Environmental Referral and Assessment Sheet

#A2021/12461

DA No.	10.2021.170.1
Proposal:	Mixed Use Development comprising Twenty Seven (27) New Eco Tourist Facility Cabins, Seven (7) Ancillary Buildings including Wellness Facility, Refuges, Depot, Addition of Deck to Existing Centre and Associated Earthworks and Vegetation Removal, and Change of Use of Fourteen(14) Private Education Accommodation Units to Eco Tourist Facility Units
Property description:	PT: 1 DP: 1031848 951 Broken Head Road BROKEN HEAD
Parcel No/s:	238081
Applicant:	Planners North Pty Ltd
Owner:	BHCF Pty Ltd
Zoning:	Zone No. E2 Environmental Conservation / PART E3 Environmental Management / PART RU2 Rural Landscape / PART SP1 Special Activities / PART DM Deferred Matter
Planning Officer:	Mr I C Holland
Referral Date:	14 April 2021
OSMS	Is the Section 68 (Onsite) concurrent with the DA: No (Delete OSMS assessment from the end of the document
Environmental Health Officer	E Holt

Figure A: Linnaeus STP Upgrade (AWC, 2020).

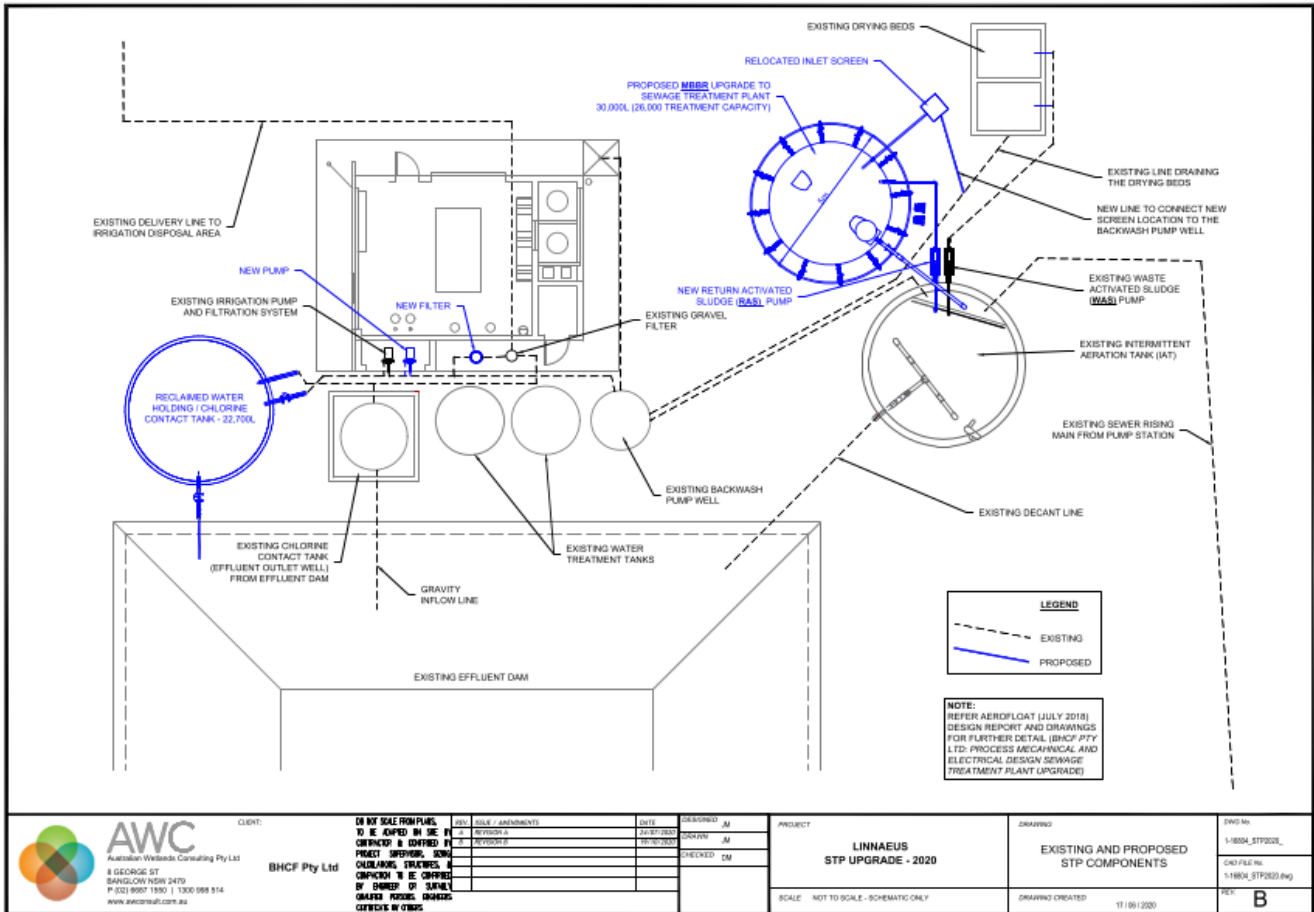
The proposed volume of wastewater is expected to be equivalent to 148.5 people per day and including the existing development the combined load will be 22.6KL/day. Therefore, a further superior STP upgrade is required to facilitate the expected wastewater and the load generated by the development.

A design plan prepared by AWC (refer Figure A) below shows the apparatus required for the proposed STP upgrade (a written summary is provided refer above).

Figure B: Land application area overview (Think Water, 2021)

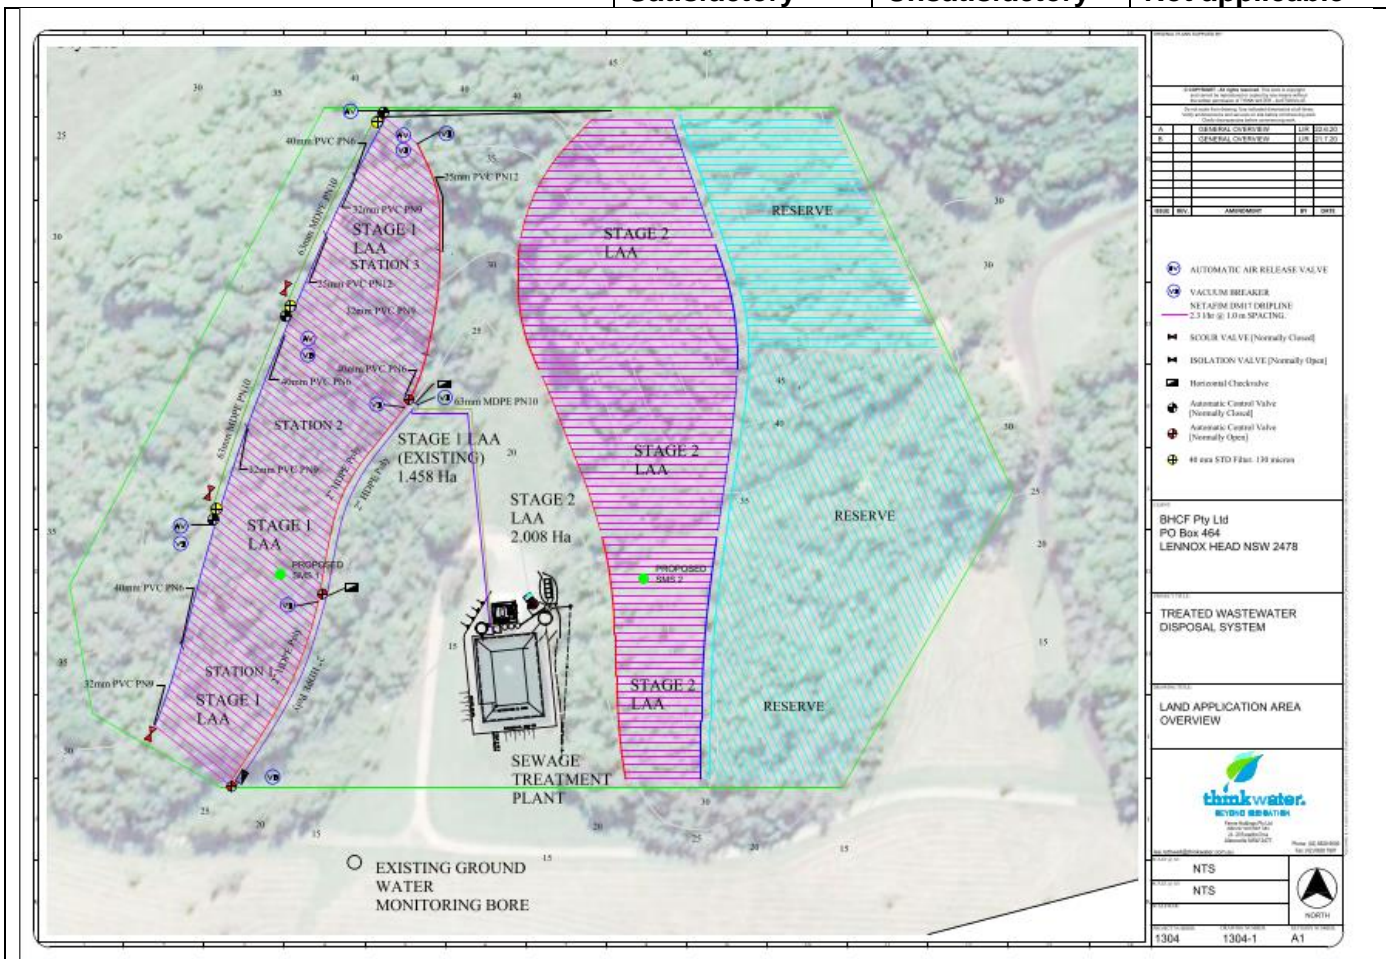
Report entitled 'Land Capability Report – Treated Wastewater Disposal Ref: 1-16804_04_b prepared by AWC dated 02/11/2021' demonstrates that the 3.446 hectares of subsurface irrigation has the capacity to adequately dispose of 51,750L/day, (refer to Figure B).

Therefore, the STP has the ability to manage and dispose of wastewater from the proposed development if the following factors are implemented:

- The STP is upgraded and continues to produce highly treated wastewater as required by Byron Shire Council's Approval to Operate (ATO)
- The irrigation system is partially constructed, and the full irrigation system is constructed
- The wastewater load is 22.6KL/day or less and to a Section 68 assessment process.
- Management of the system including monitoring, reporting and maintenance continues as stipulated in Byron Shire Council's Approval to Operate (ATO)

As indicated above AWC have demonstrated that the STP can manage the combined wastewater load of 22.6KL/day from the proposed (combined) development.
